**BIDDING AND CONTRACT DOCUMENTS**  
**ADDENDUM NUMBER ONE**  
**STATE PROJECT NO. 13-045B-1**

DATE: JANUARY 15, 2014

CAMDENTON MEMORIAL AIRPORT

SUBJECT: ADDENDUM NUMBER ONE TO THE BIDDING DOCUMENTS FOR:  
HANGAR B TAXILANE RECONSTRUCTION

SHEET 12 OF 19 SHEETS

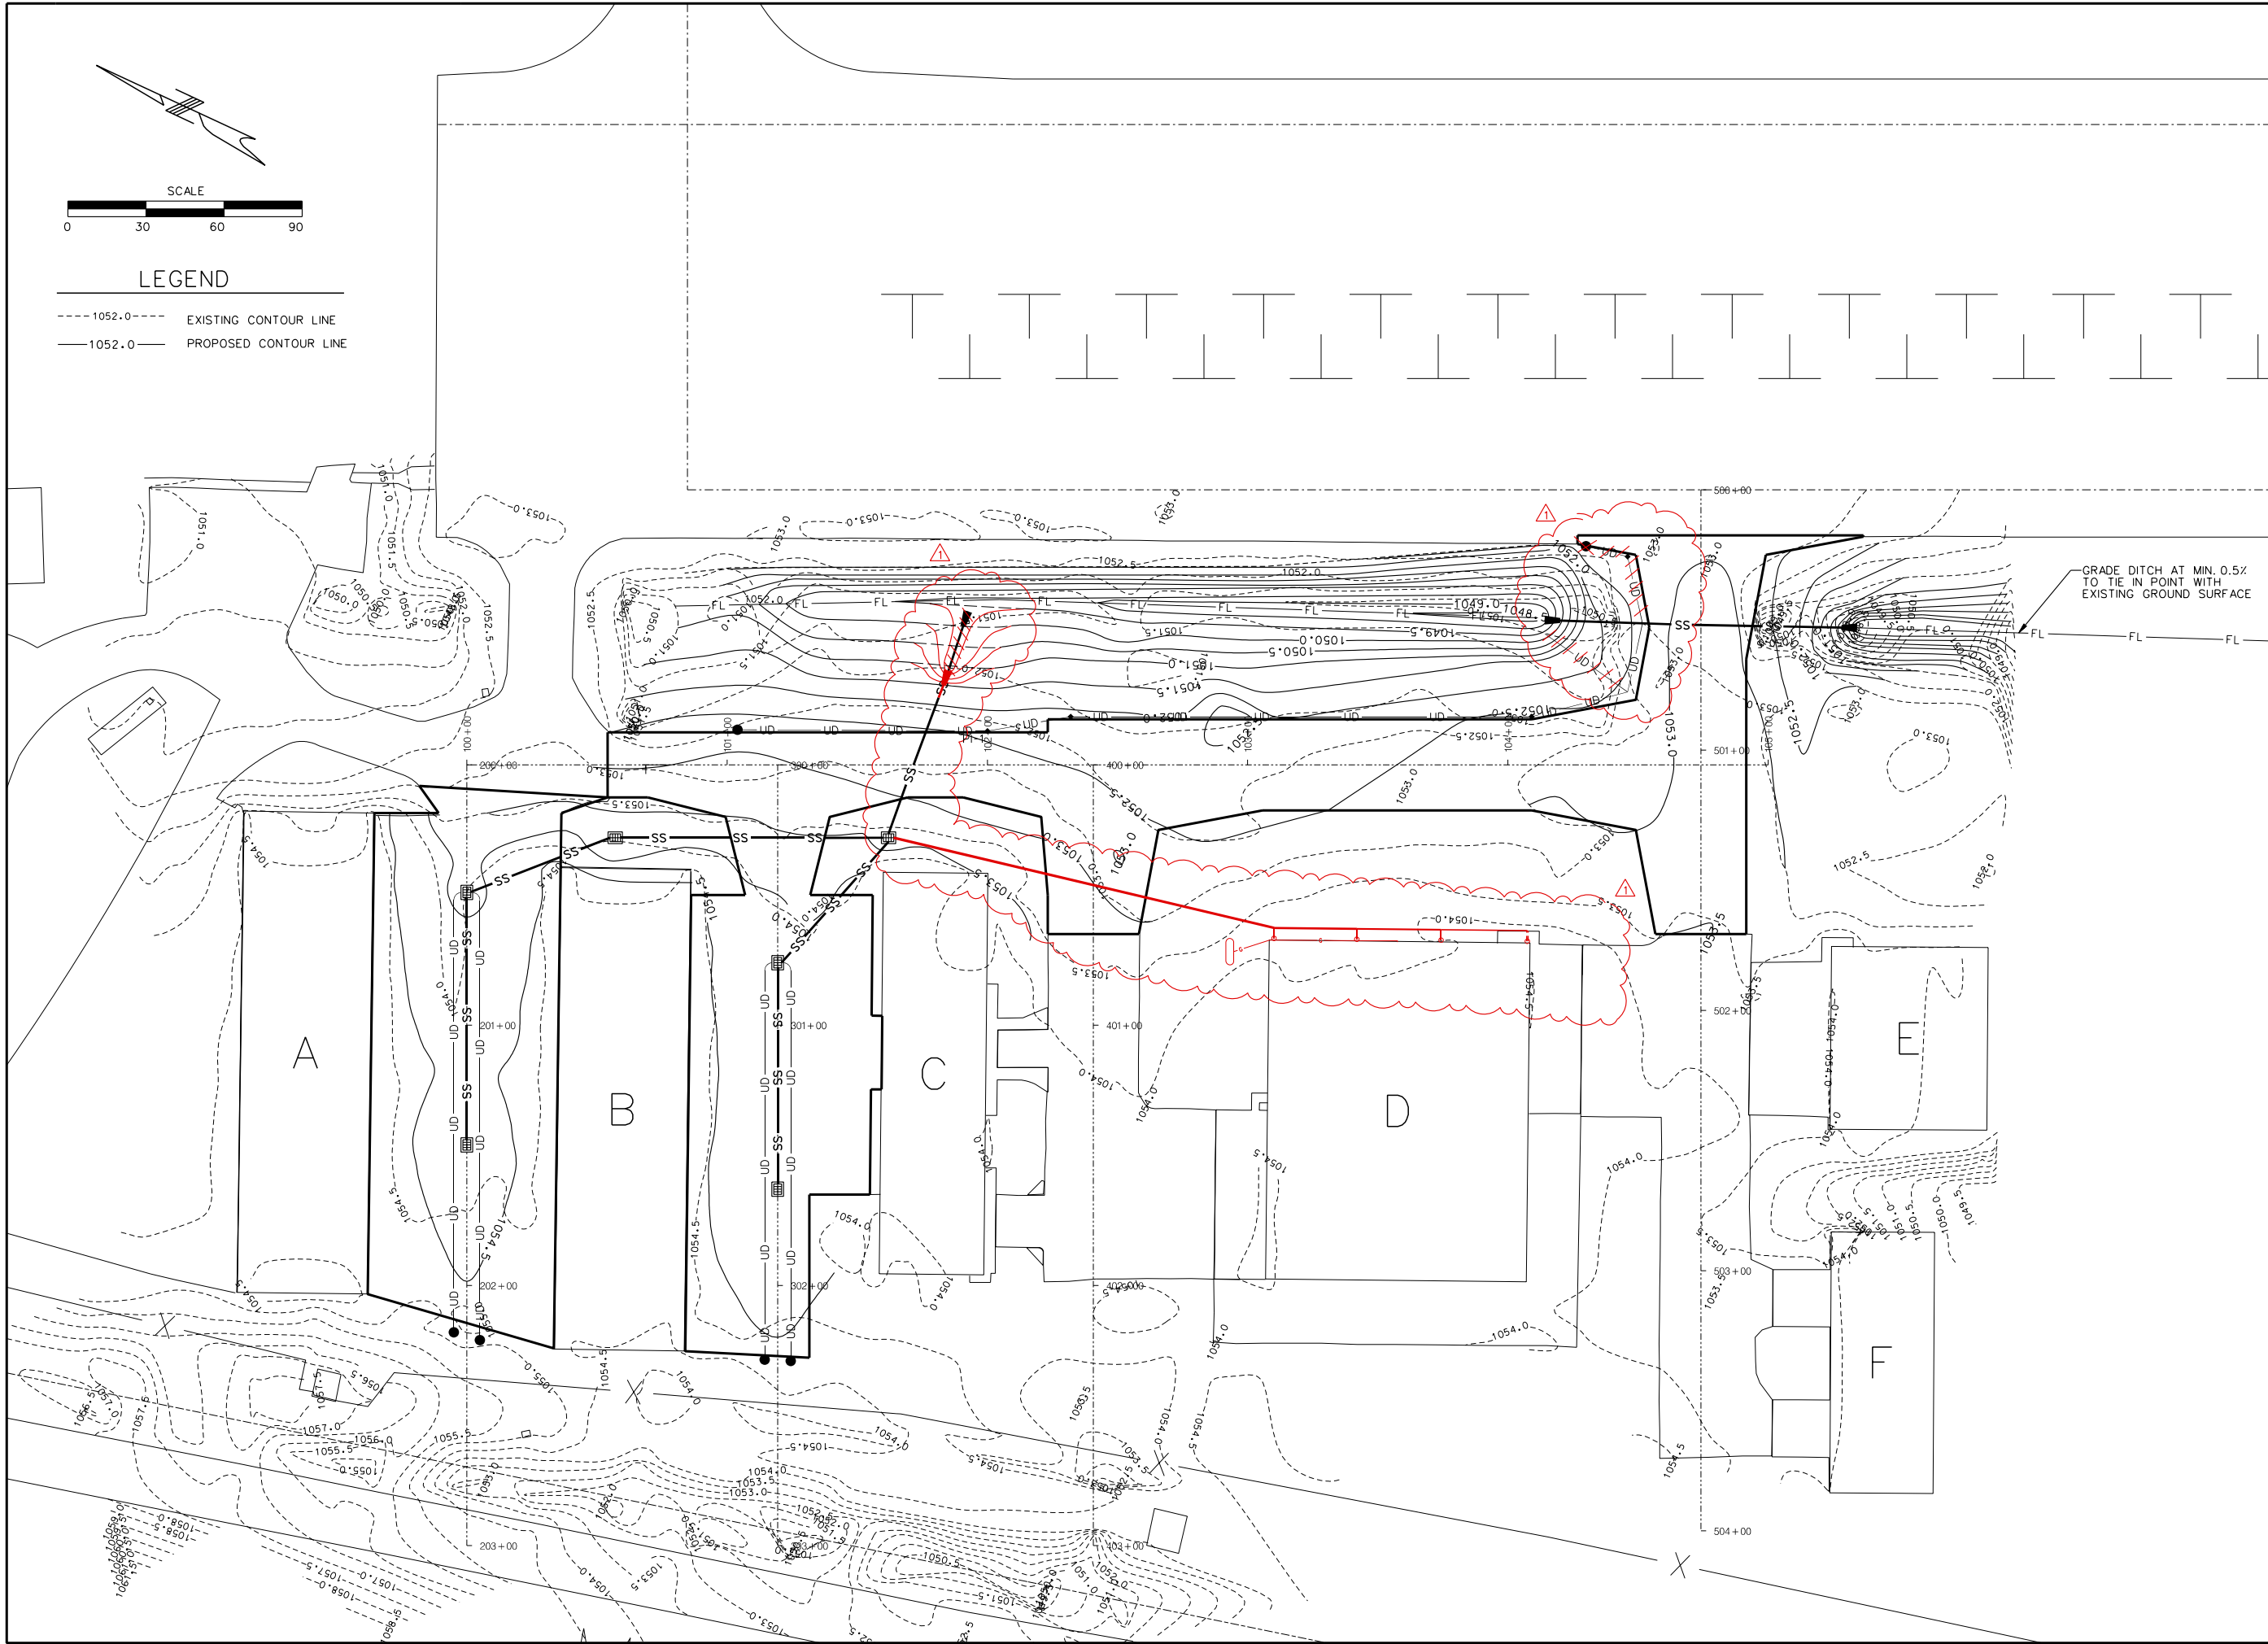
REPLACE Sheet 12 of 19 with Revision 1.

## HANGAR D ROOF DRAINAGE NOTES

- CONTRACTOR SHALL VERIFY EXISTING LOCATION AND ELEVATION OF SOUTHERN MOST DOWNSPOUT OUTLET PIPE PRIOR TO INSTALLING THE PROPOSED DRAINAGE PIPING. IF THE FLOWLINE ELEVATION IS BELOW THE PROPOSED ELEVATION OF THE NEXT CONNECTION THE CONTRACTOR SHALL NOTIFY THE ENGINEER AND THE ENGINEER WILL UPDATE THE PROPOSED FLOWLINE ELEVATIONS.

- EXISTING PIPING RUNS UNDERGROUND TO EXISTING LEACH FIELD. CONTRACTOR SHALL REMOVE ANY EXISTING PIPE THAT IS IN DIRECT CONFLICT WITH THE PROPOSED PIPING AND MAY ABANDONE THE REMAINING PIPE IN PLACE.

- REPLACE EXISTING 6" PVC PIPE TO ABOVE GROUND CONNECTION WITH DOWNSPOUT (TYP. OF 3 OF 4 LOCATIONS).
- APPROXIMATE QUANTITIES INCLUDE 50 LF OF 6" PVC, 32 LF OF 8" PVC, 32 LF OF 10" PVC AND 150 LF OF 12" PVC PLUS REQUIRED FITTINGS.
